The Commission has issued the enclosed Amendments Nos. 40 and 39 to Facility Operating Licenses Nos. DPR-32 and DPR-37 for the Surry Power Station, Units Nos. 1 and 2, respectively. These amendments consist of changes to the Technical Specifications for each license in response to your five separate applications dated September 27, 1976, May 19, 1977, May 20, 1977, October 18, 1977 and November 3, 1977.

These amendments permit incorporation in the Technical Specifications of Commission requested changes regarding the qualifications of the Health Physics Supervisor and in the automatic power distribution monitoring system. In addition, changes are made in the surveillance procedures for various components of the engineered safety features in the containment spray nozzle tests, and in the administrative controls.

AMENDMENT TO FACILITY OPERATING LICENSE

Amendment No. 40  
License No. DPR-32

MAIN STEAM AND FEEDWATER LINES - UNIT 2  
 SURRY POWER STATION  
 UNITS 1 AND 2

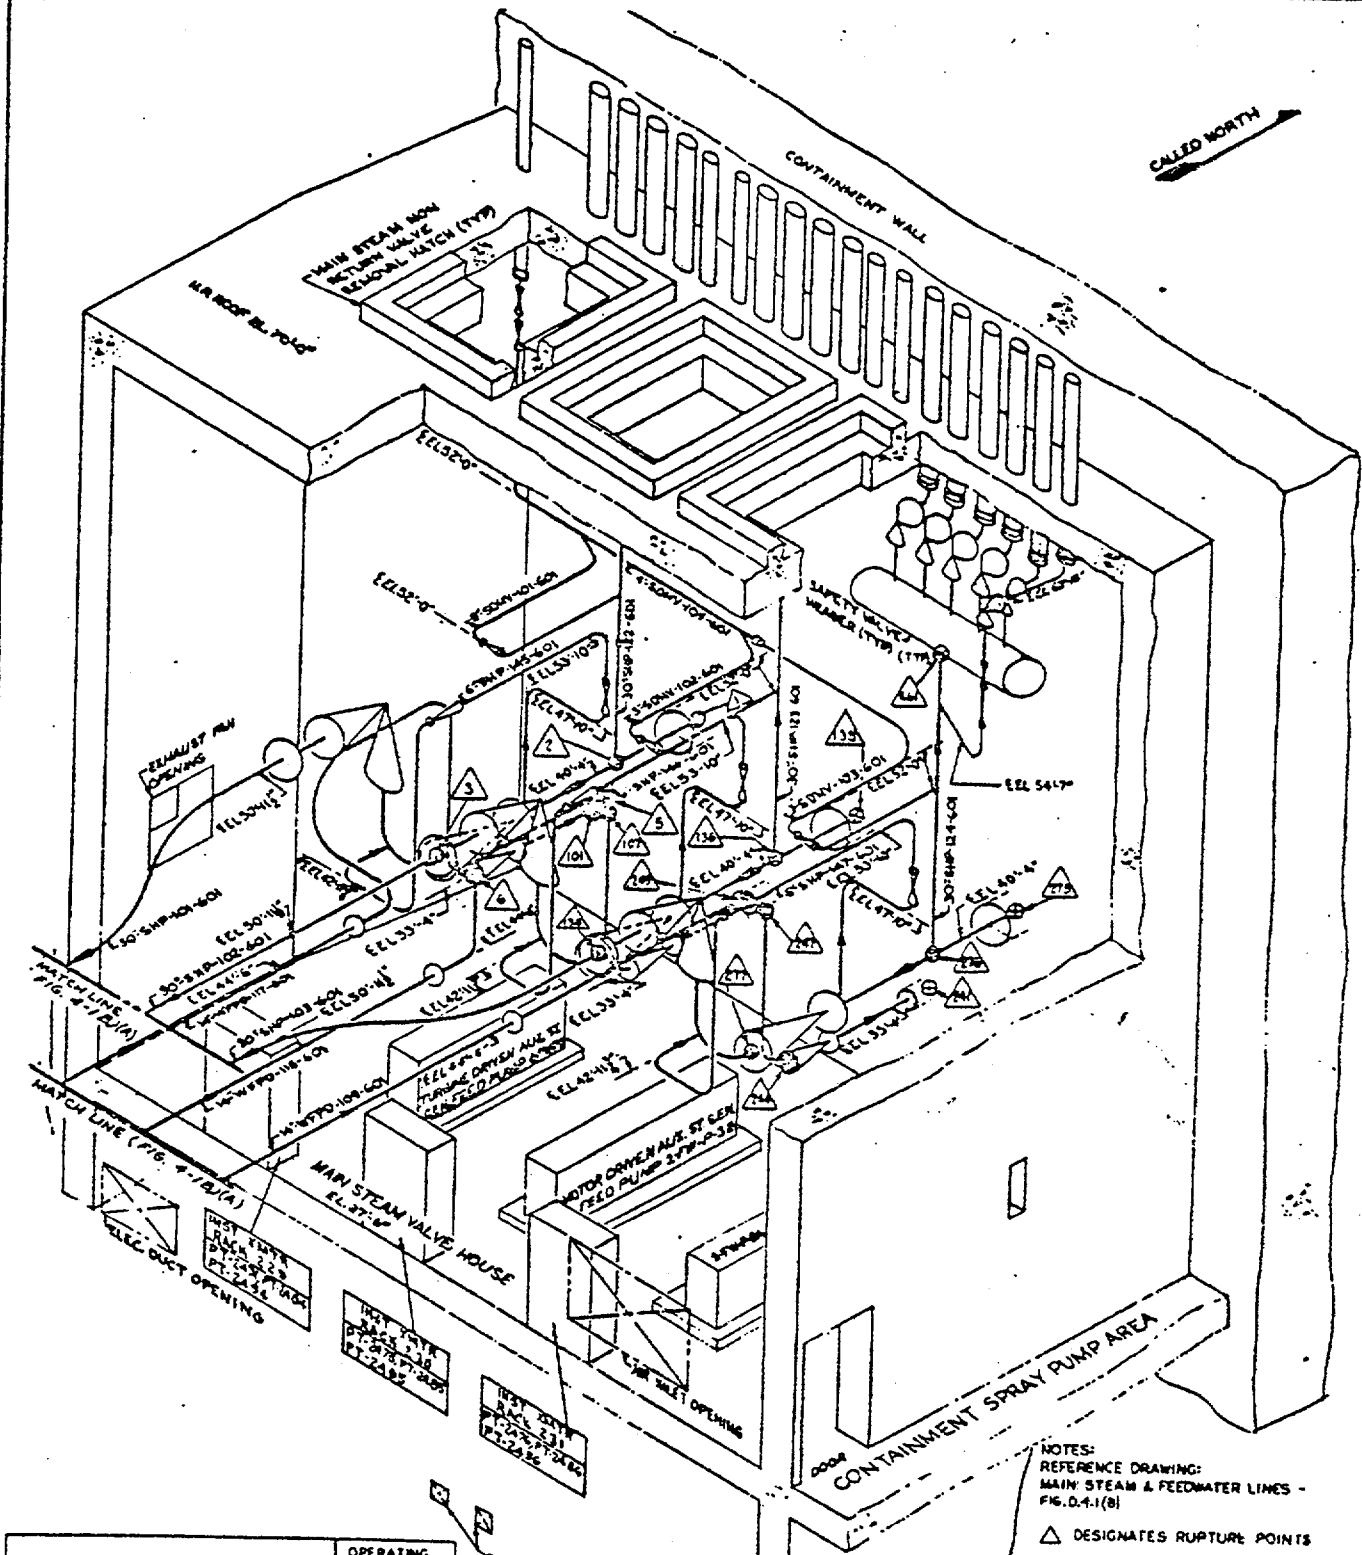
- A. For the 17 welds identified in TS Figure 4.15:
  - 1. At the first refueling outage period a volumetric examination shall be performed with 100 percent inspection of welds in accordance with the requirement of ASME Section XI Code, Inservice Inspection of Nuclear Power Plant Components, to

- B. For all welds other than those identified in TS Figure 4.15:
1. Welds in the main steam lines including the safety valve headers and in the feedwater lines in the main steam valve house shall be examined in accordance with the requirements of subsection ISC 100 through 600 of the 1972 Winter Addenda of the ASME Section XI Code.

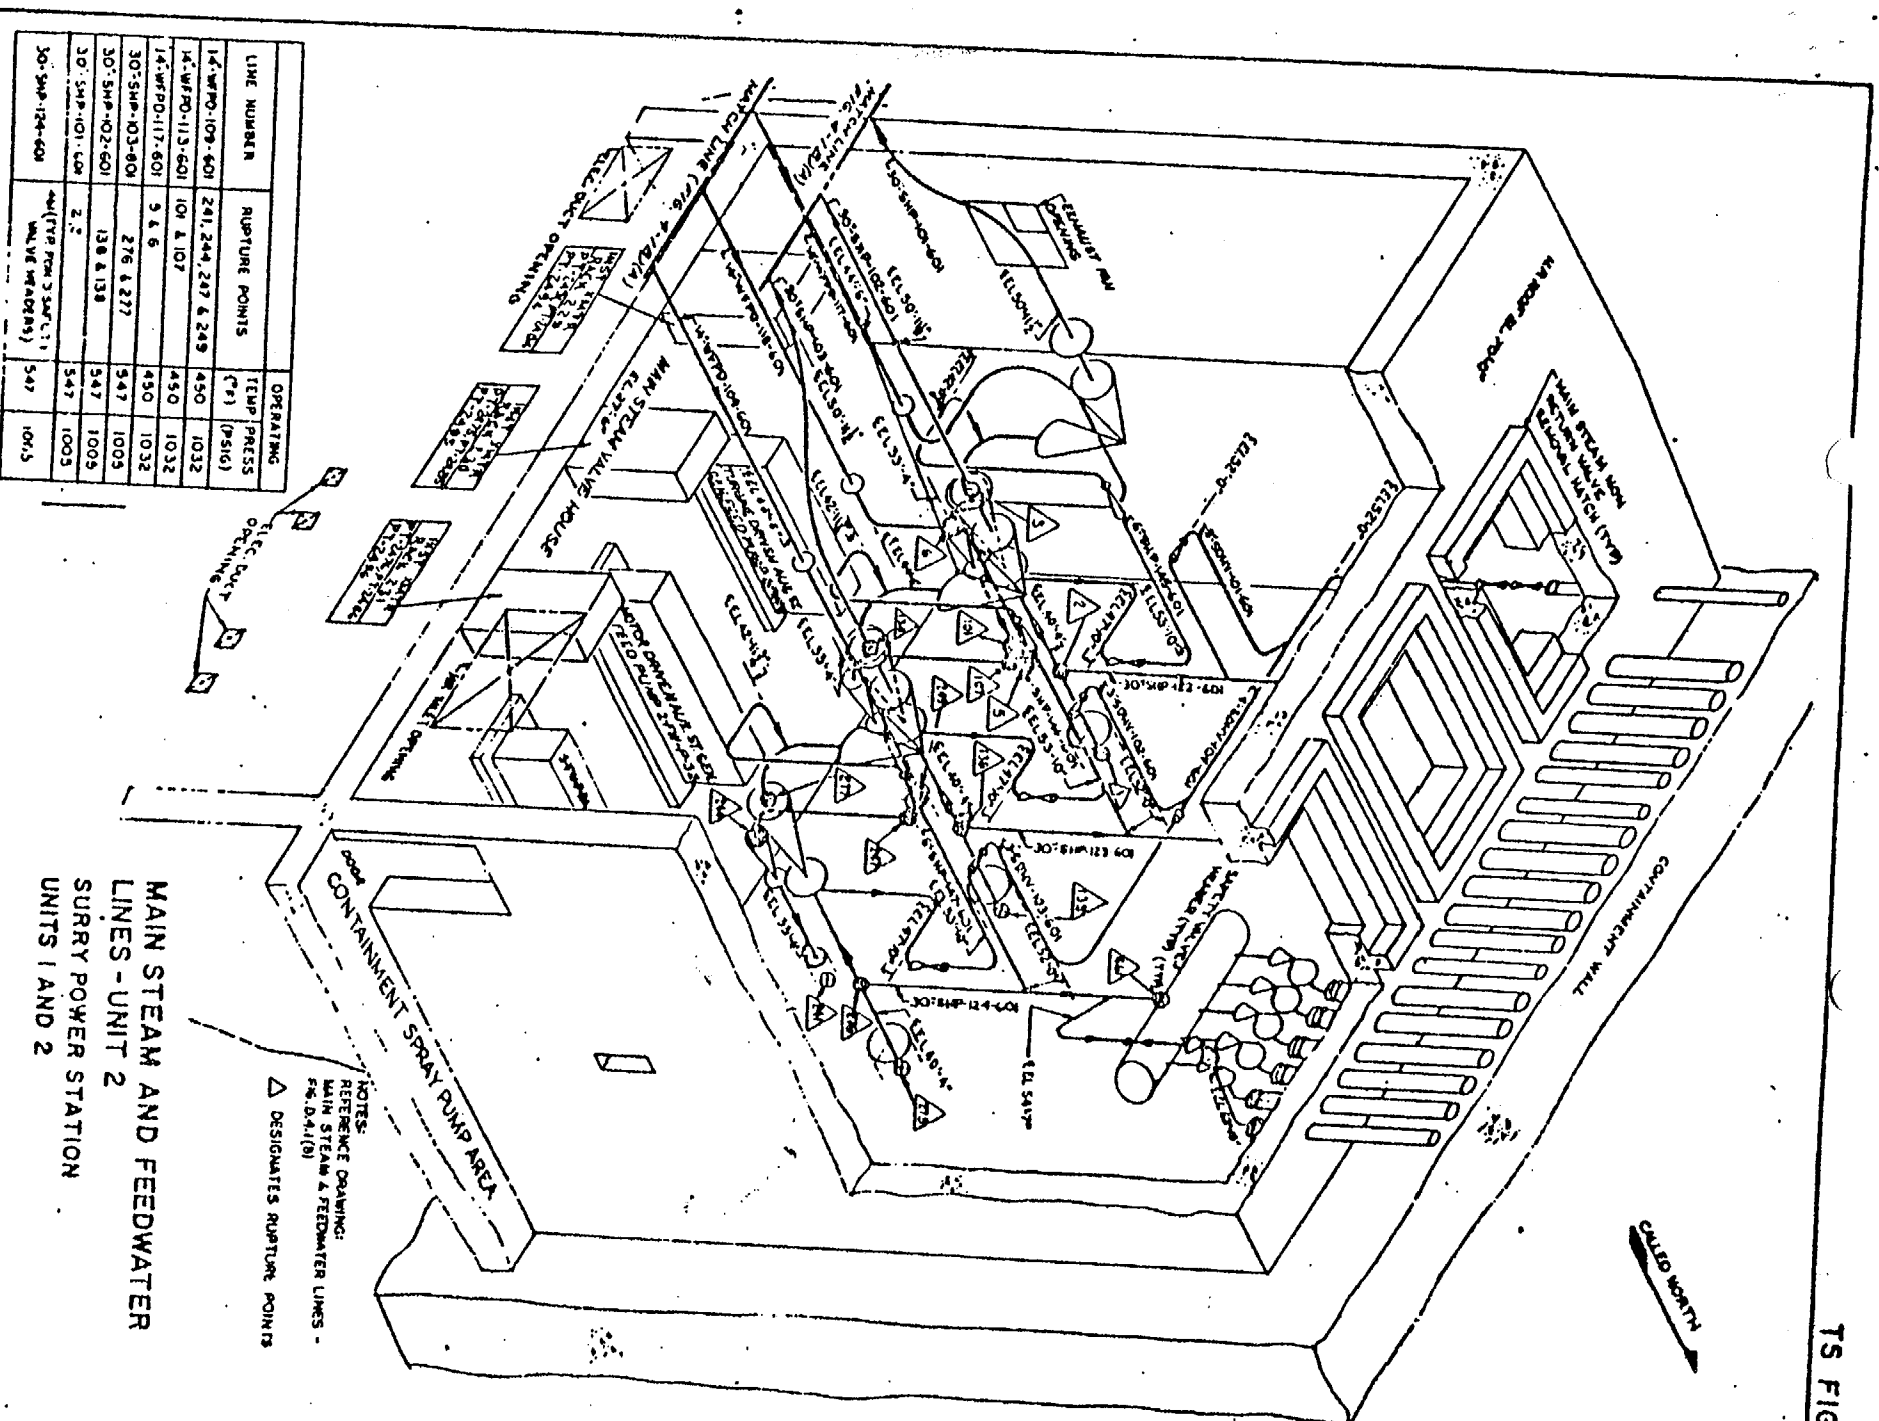
- A. For the 17 welds identified in TS Figure 4.15:
  1. At the first refueling outage period a volumetric examination shall be performed with 100 percent inspection of welds in accordance with the requirement of ASME Section XI Code, Inservice Inspection of Nuclear Power Plant Components, to

B. For all welds other than those identified in TS Figure 4.15:
